**Metro Gold Line Eastside Extension  
Four Quadrant Gate Feasibility Study**

September 2009

**REPORT OF THE  
AMERICAN PUBLIC TRANSPORTATION ASSOCIATION  
PEER REVIEW PANEL  
ON THE  
EASTSIDE CORRIDOR LRT ALIGNMENT  
OF THE  
LOS ANGELES COUNTY  
METROPOLITAN TRANSPORTATION  
AUTHORITY**

Figure 1 – No Trespass and No Vehicle Signs

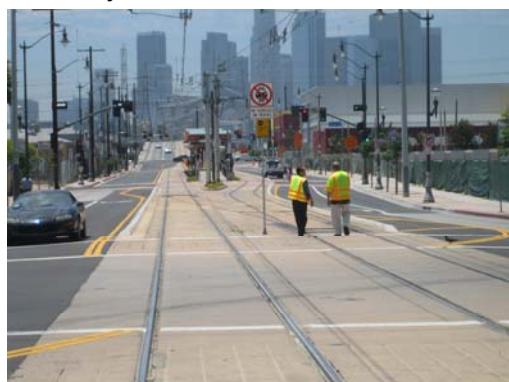
Signs have been placed within the 1<sup>st</sup> Street and 3<sup>rd</sup> Street trainways to warn pedestrians of trespass and motorists that vehicles are not permitted on the tracks. These signs are appropriate. However, the No Trespass sign size and lettering appear to be too small. The team was not able to easily read the sign until they were in the trainway itself, defeating the purpose of the sign. On the other hand the "No Vehicle on Tracks" sign and "No Vehicles" symbol sign, appear to be appropriately sized. See Figure 1

#### Recommendation 1 – No Trespass Signs

*Evaluate the size of, and the lettering on, the "No Trespass" signs for readability and effectiveness. The signs should be able to be read before entering the trainway.*

**Recommendation 9 – Swing Gates**

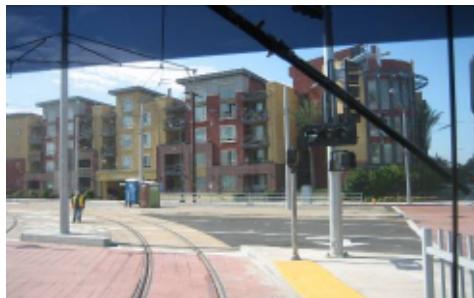
At several locations; however, the direction of the swing did not properly orient the passenger toward the approach of a train. It is recommended that each gate be evaluated for proper orientation.

*Evaluate the direction of the station swing gates to ensure that they properly orient a passenger toward the direction of an approaching train.*

**1<sup>st</sup> Street and Gless Avenue**

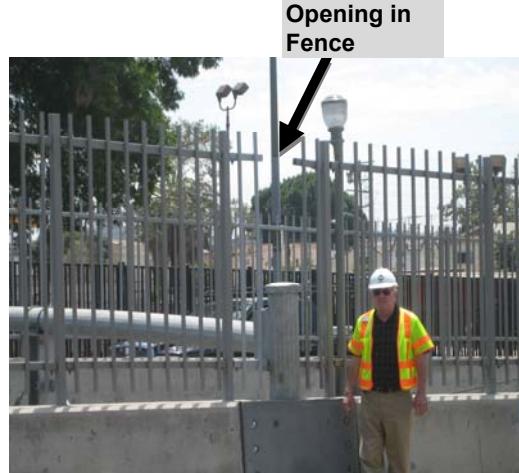
1<sup>st</sup> Street and Gless Avenue is the locality of the west end of the tunnel. Prior to the construction of the tunnel portal, vehicular traffic was permitted to cross 1<sup>st</sup> Street at this location. Now, high curbs with large reflective paddles on top have been put in place as a crossing barrier. A number of active and passive signs were also in place, informing motorists that they must not turn and proceed straight ahead. Although no damage to the barrier was found, the signage at this location

was cluttered and may be confusing. There were “No U Turn” and “No Left Turn” signs on Gless Street (only right turns are permitted. Signage at this location should be evaluated.
